Product/Process Change Notice (PCN)

PCN #: PCN_IndFCL_20160713_Marking

Product Affected: WE-FCL series

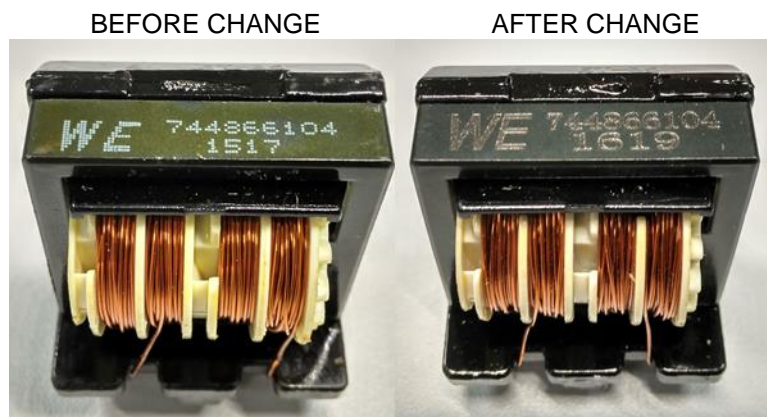
To increase the production capability, the product marking will be changed. Products after product change with effective date of 13th October 2016 are available with Date Code 2016-10-13.

The previous marking process (ink) will be changed to a laser marking process to increase the efficiency and reliability of the production process. See attached pictures:
